FIRE COMPLIANCE REVIEW

250270 HAFF NSW AT 28 FLORIDA STREET SYLVANIA NSW

FIRE SPRINKLER AND HYDRANT SERVICES

Project Number	250200
Project Name	HAFF NSW AT 28 FLORIDA STREET SYLVANIA NSW
Description	Review for compliance with EP&A Division 4.3, Section 4.15 and Section 4.17, AS2419.1-2021 and NSW F&R Access for Fire Brigade Vehicles and Fire Fighters
Key Contact	David Buckmaster

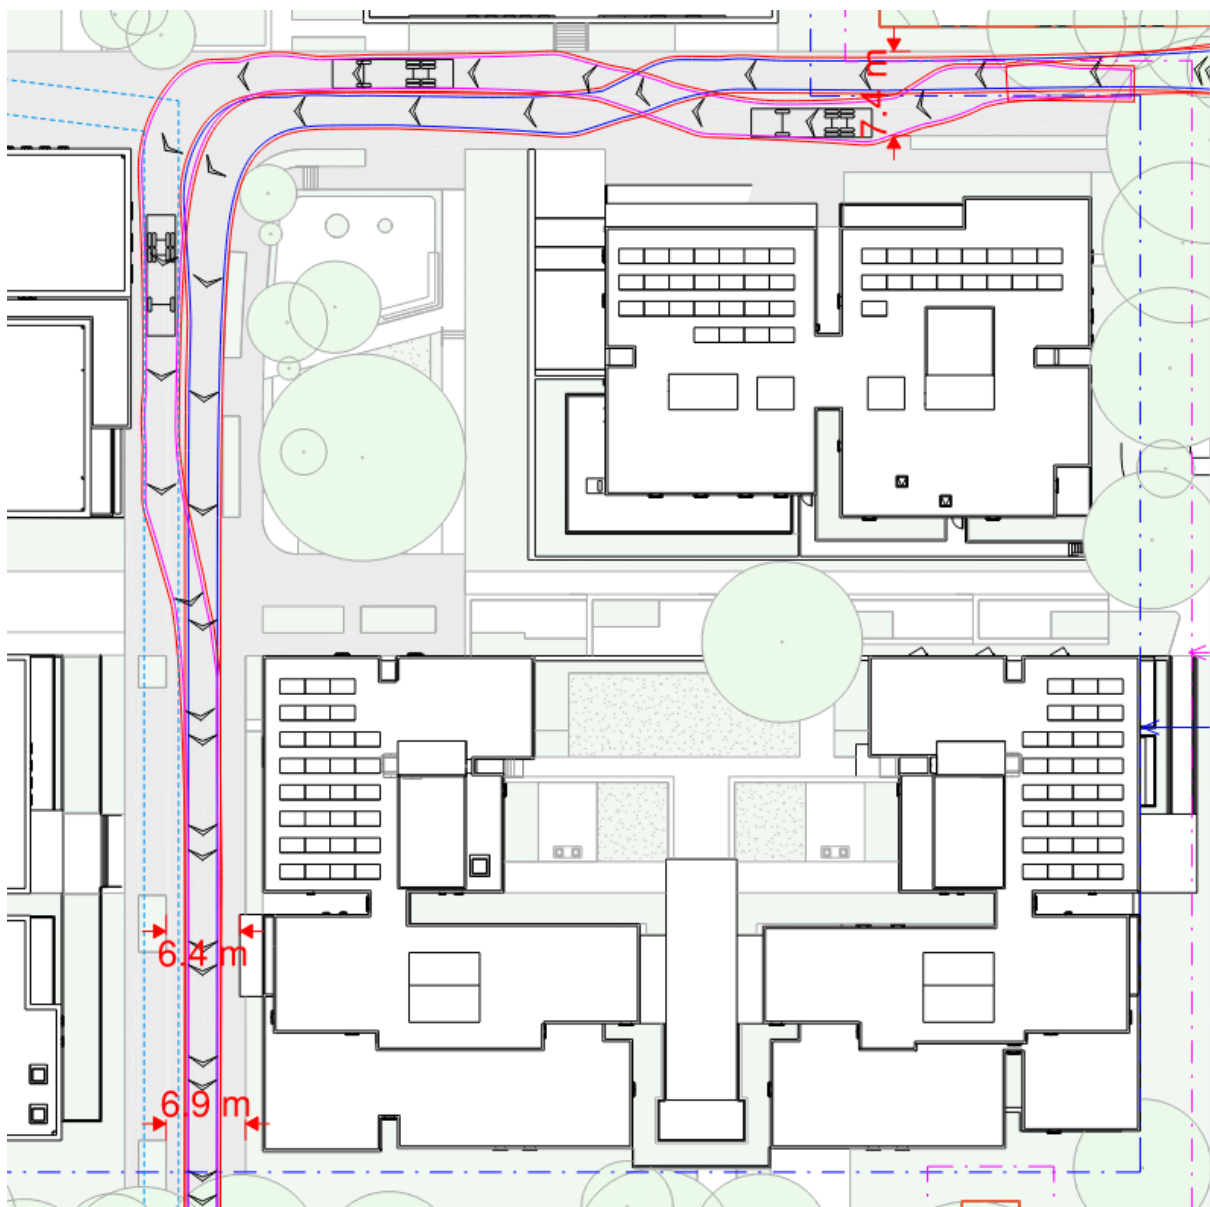
A review of AR-DA-10A-XX-05[04] shows the private road is not a dead end nor is Florida Street.

A review of AR-DA-10A-XX-05[04] which shows the travel paths and turning circles of vehicles indicates that the private roadway is never less than 6m wide. The narrowest point being 6.4m wide. See part plan of AR-DA-10A-XX-05[04] below.

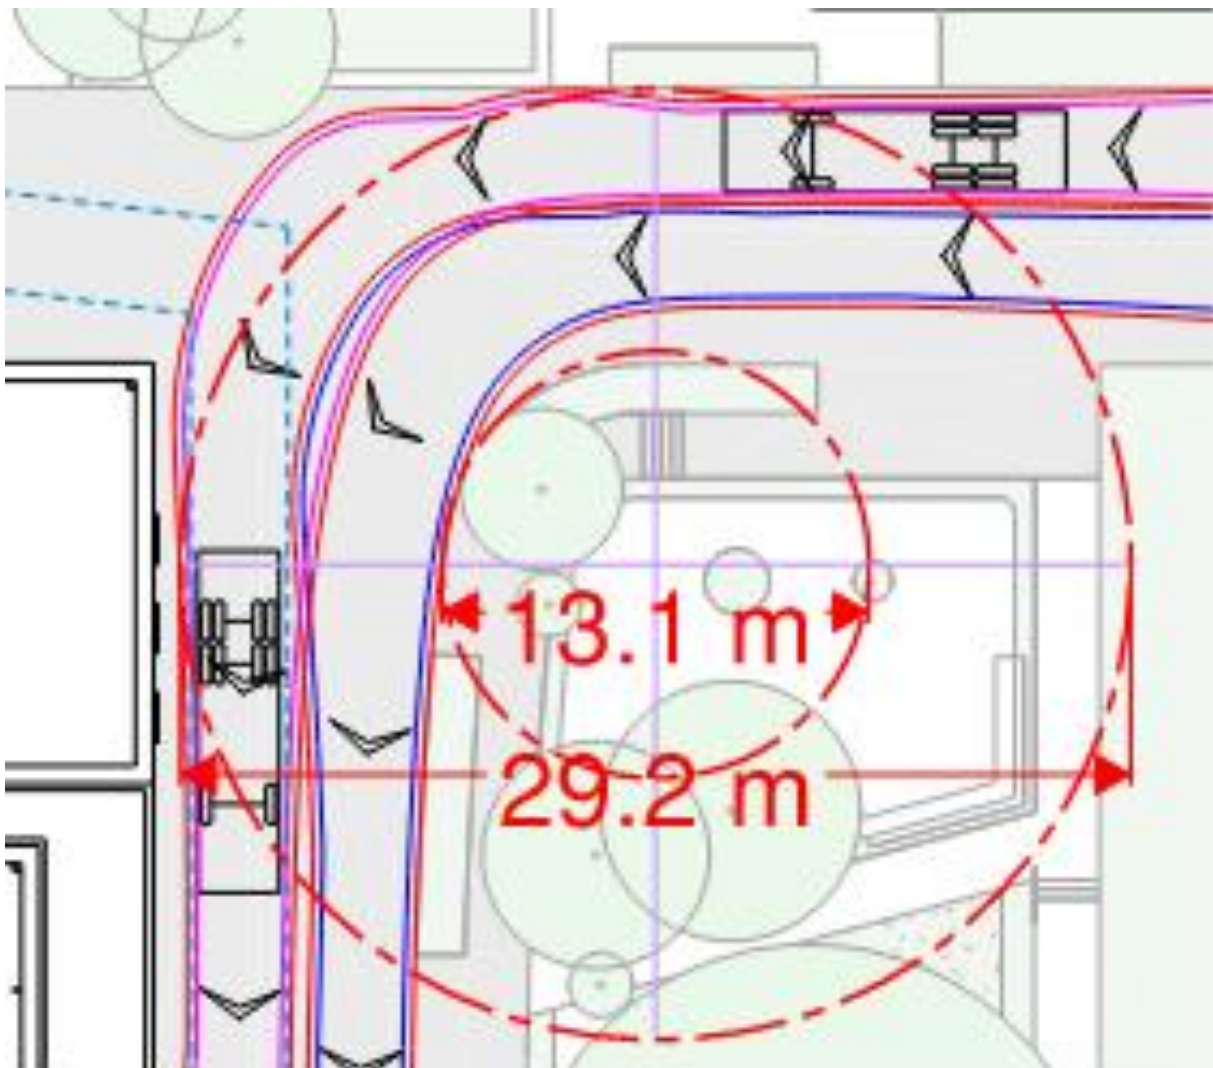
The minimum turning circles for the swept paths required by FSG-Access Clause 7.1.5 of a minimum radius of 7.1m and a maximum radius of 14.6m for the specialist vehicle have been met, see part plan of AR-DA-10A-XX-05[04] below.

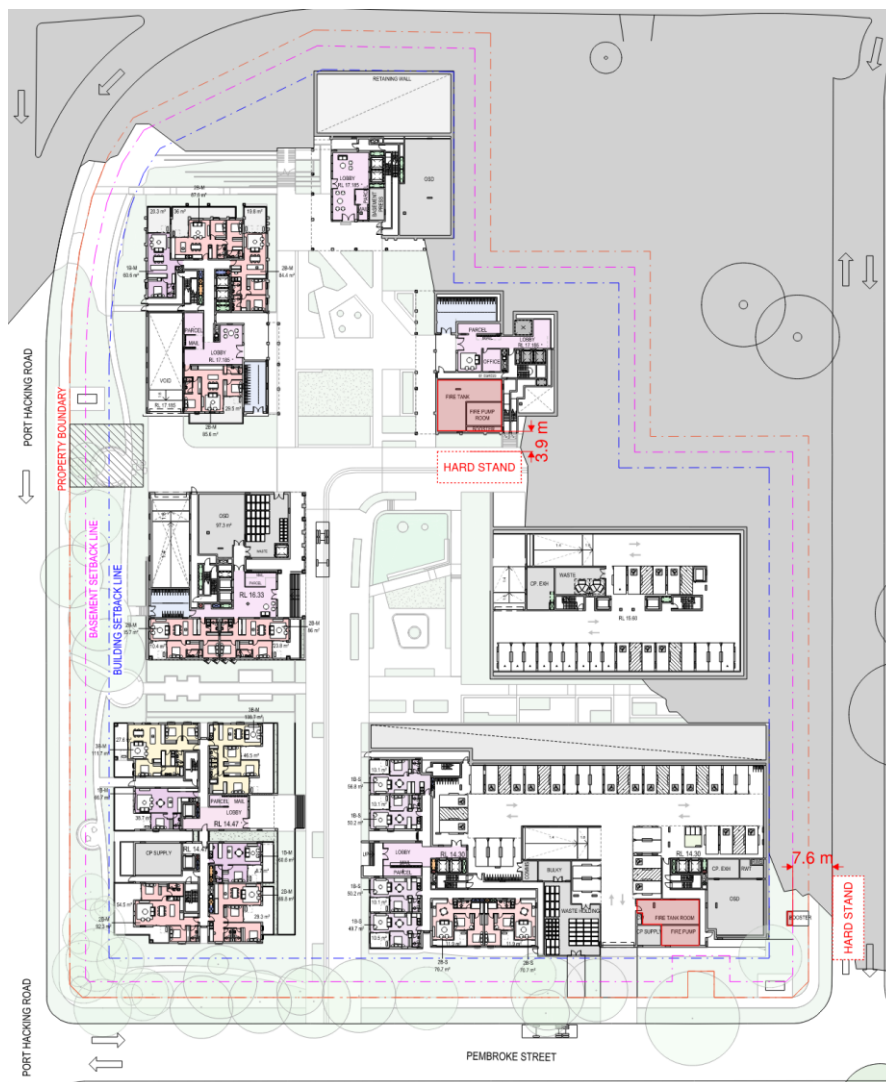
Booster assemblies for these lots are located in Building 1c and Social House Building with the hard stand on the private roadway and Florida Street respectively. A review of AR-DA-10A-XX-05[04] & AR-DA-10B-03-01[09] show that both the private roadway and Florida Street provide this hardstand in front of the booster within 8m of the booster.

AR-DA-10A-XX-05 04

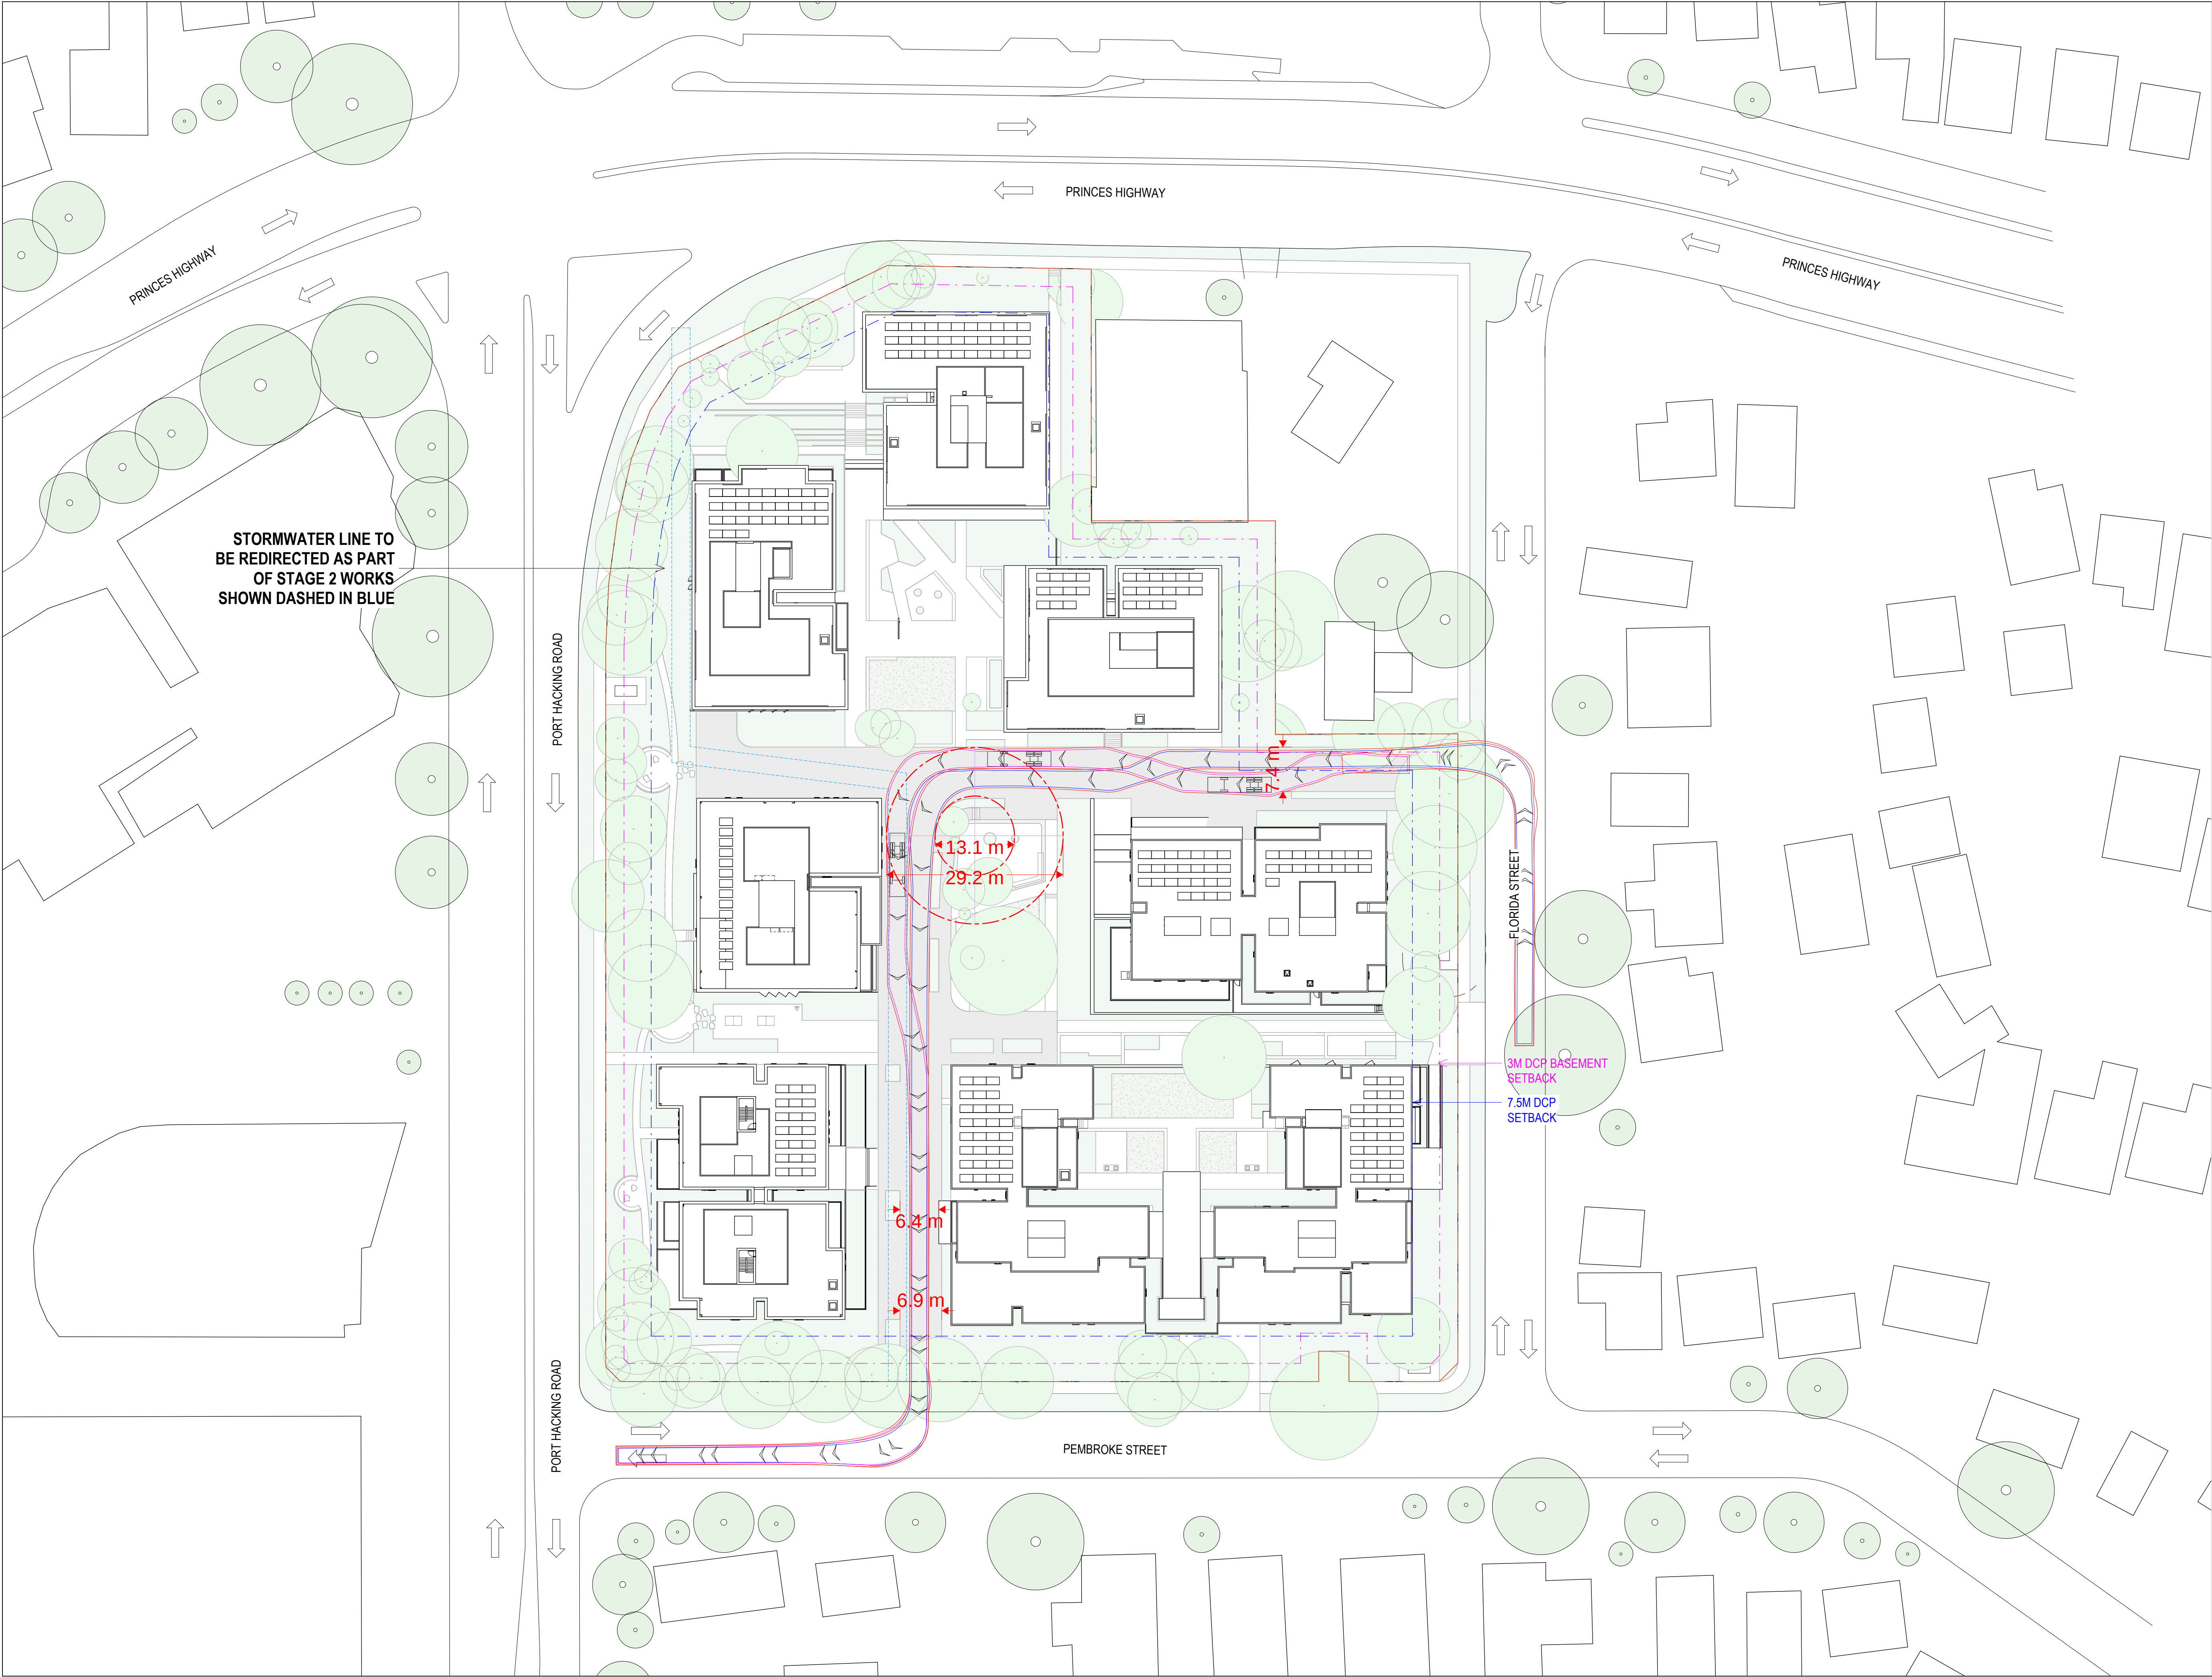
STORMWATER LINE TO
BE REDIRECTED AS PART
OF STAGE 2 WORKS
SHOWN DASHED IN BLUE
